Revision Transmittal

SUBJECT: Service Bulletin SEB89-1 Revision 3, Stabilator Balance Weight Arm Bracket Inspection/Replacement.

SEB89-1
Revision 3

STABILATOR BALANCE WEIGHT ARM BRACKET INSPECTION/REPLACEMENT

Figure 1. Stabilator Balance Weight Arm Brackets Inspection & Replacement (Sheet 1 of 4)

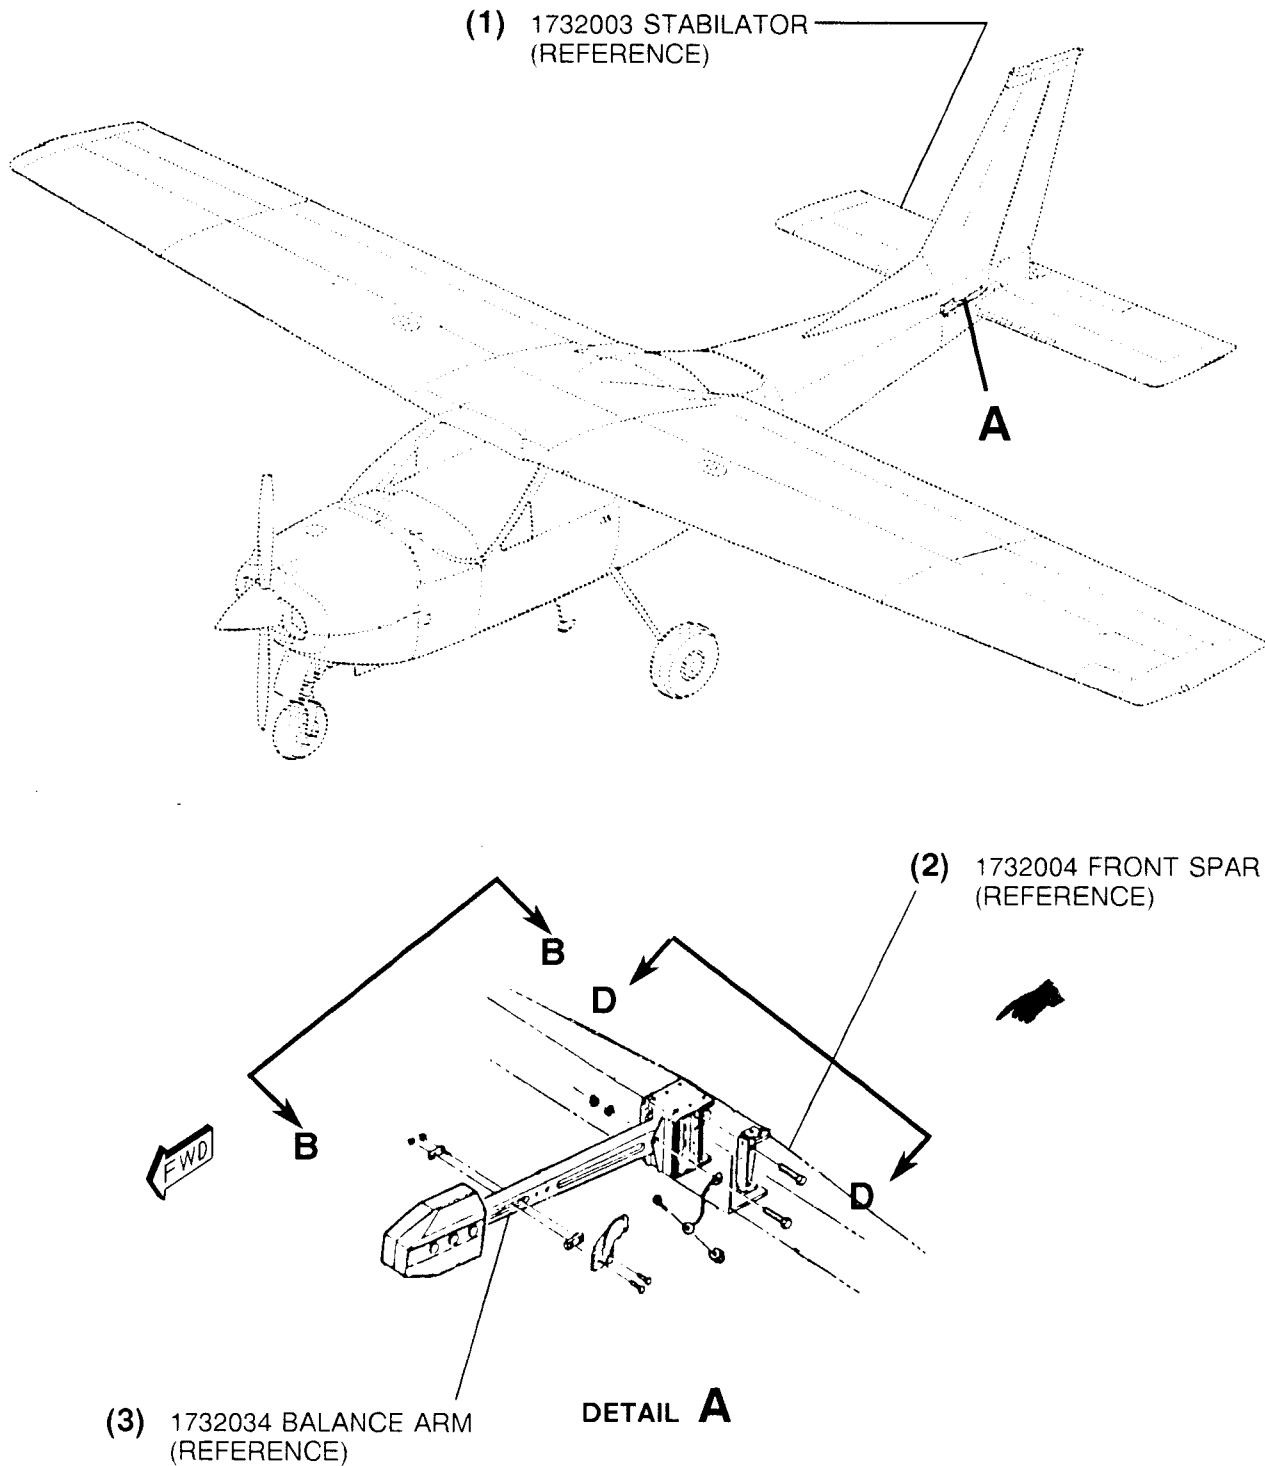
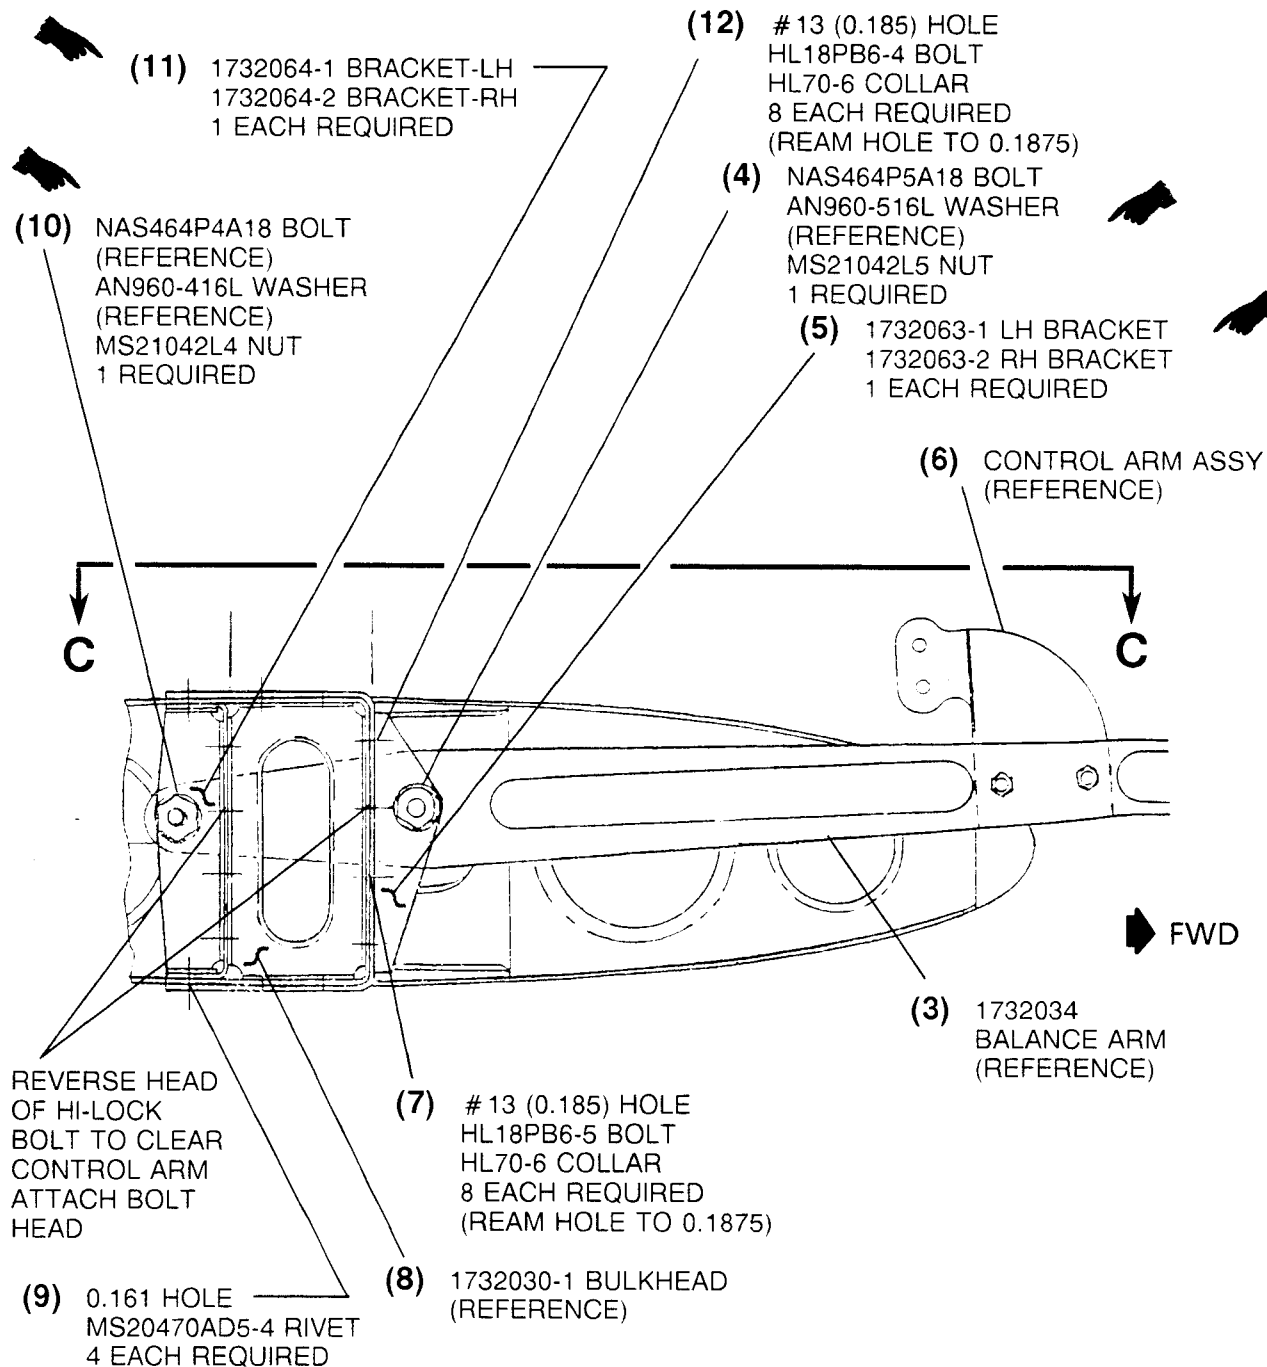
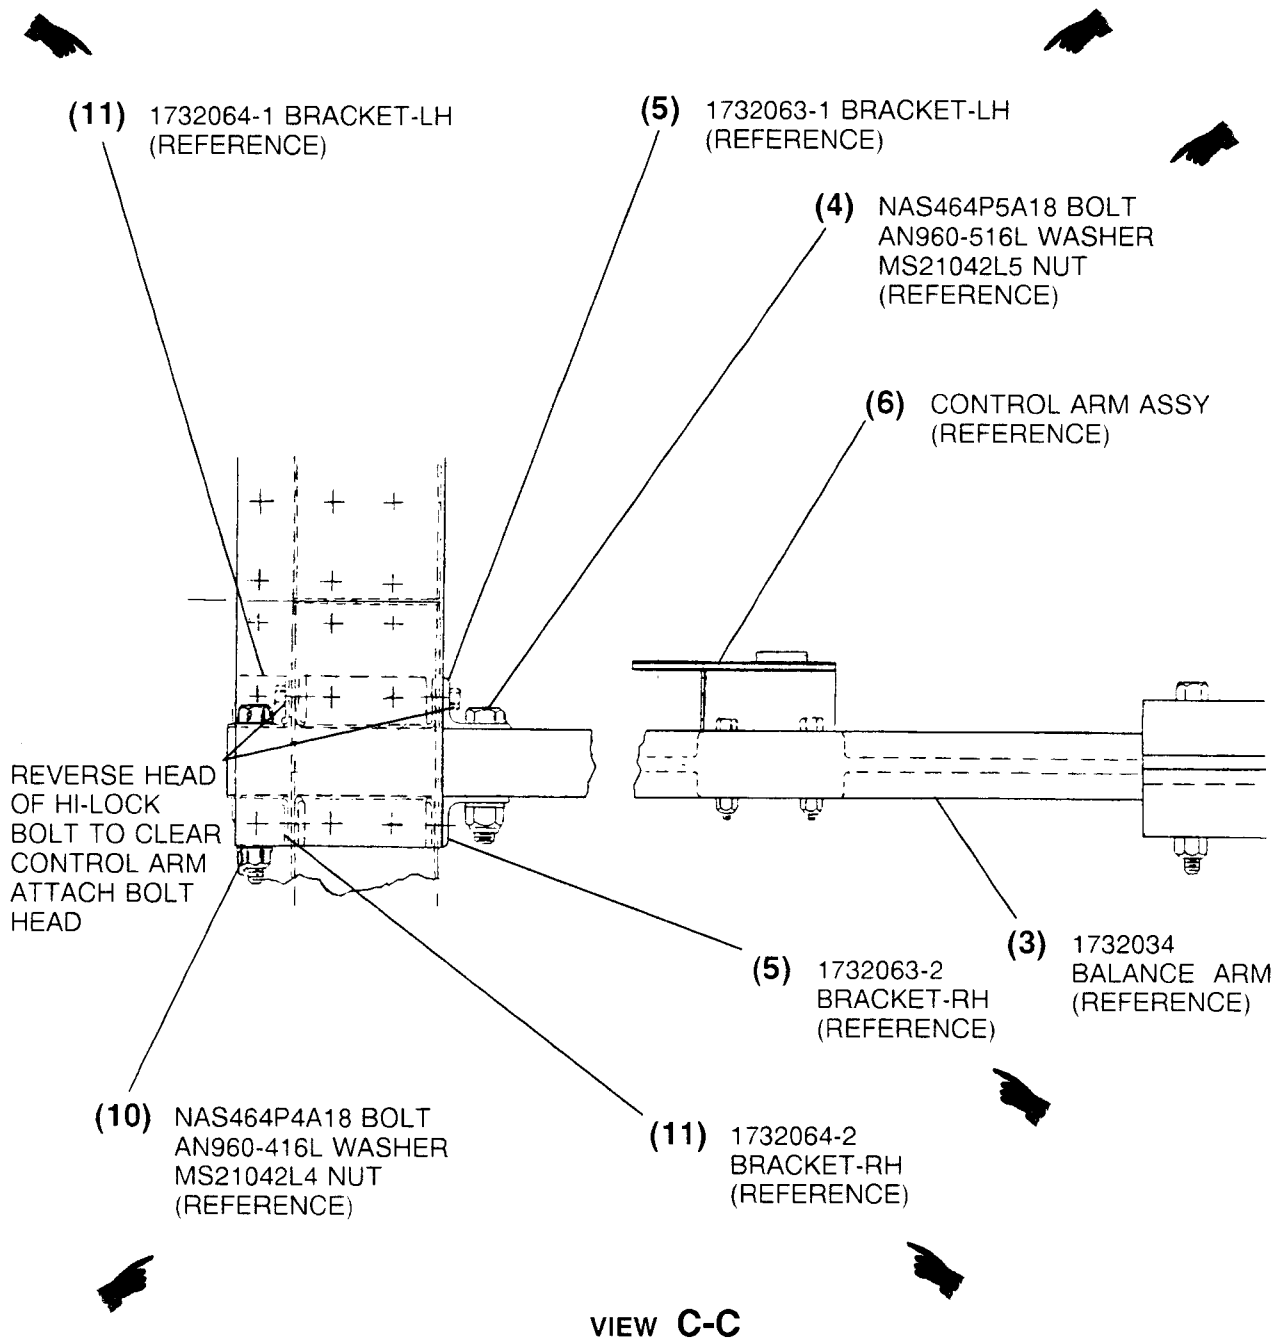
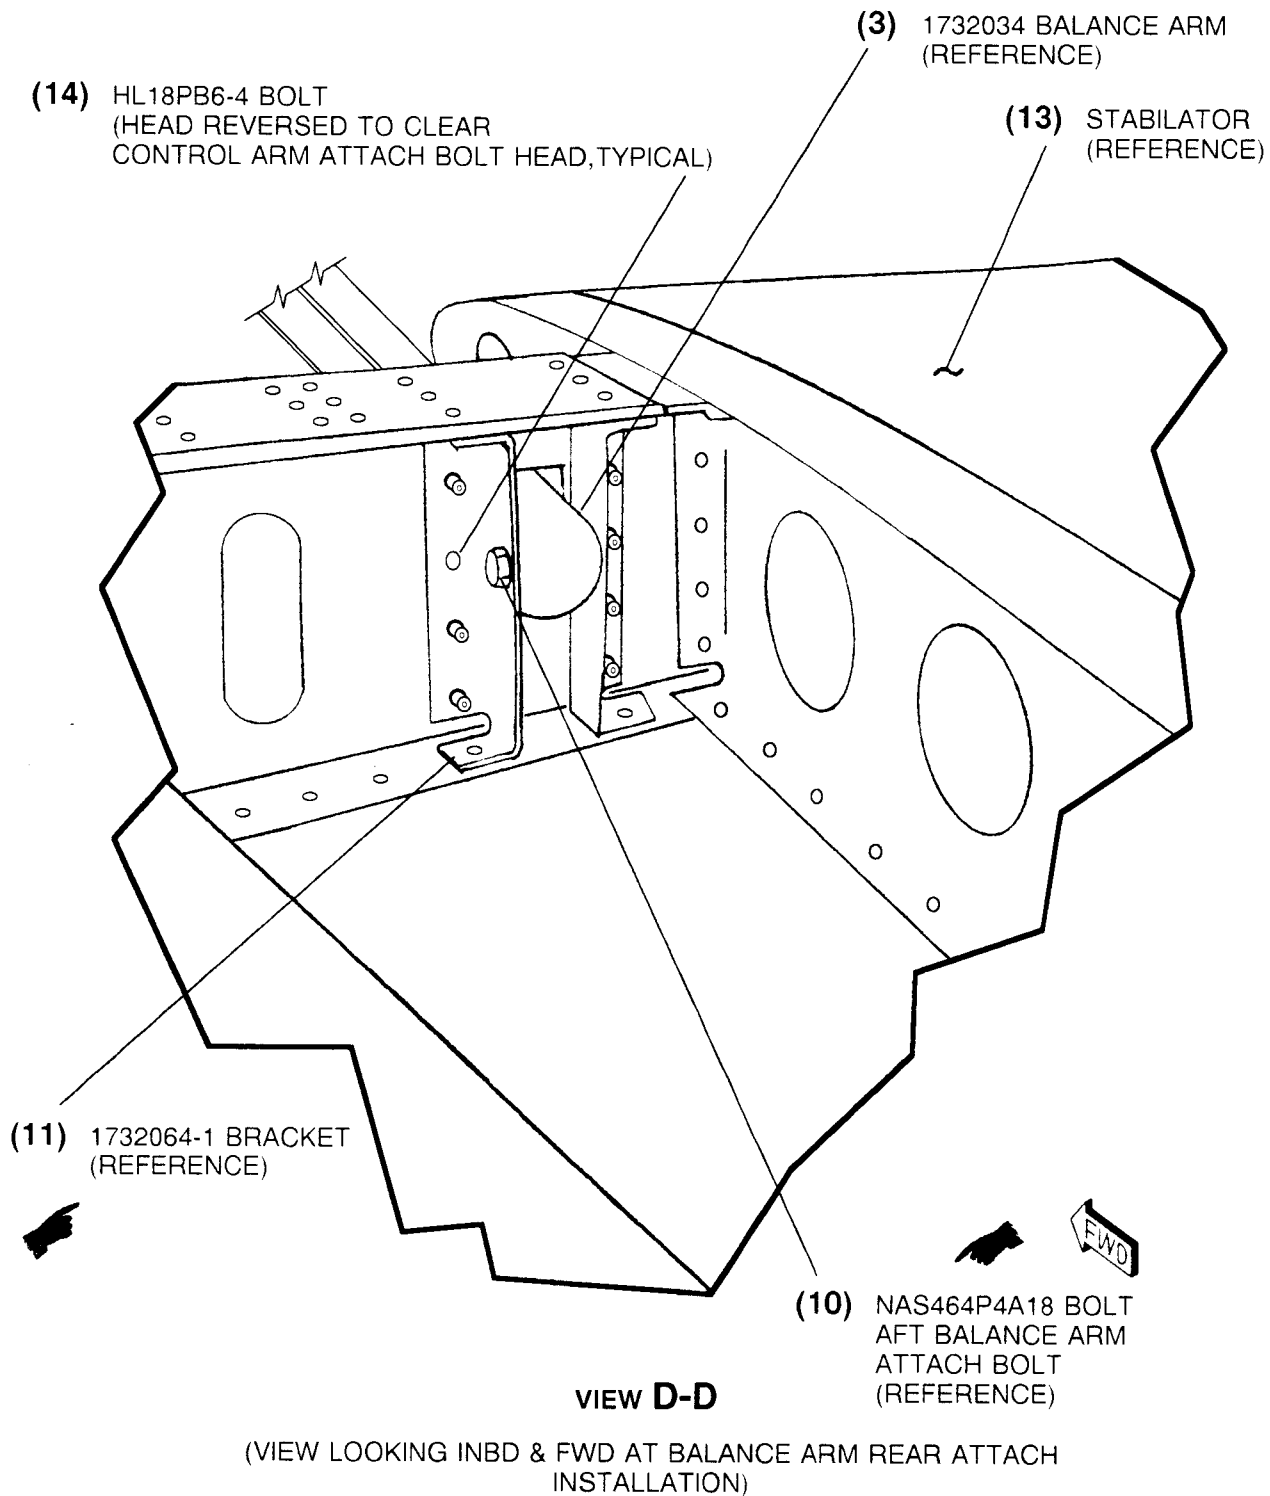
To correct various part number callouts within the illustrations of the Attachment Instructions.
Miscellaneous changes to other sections as required.
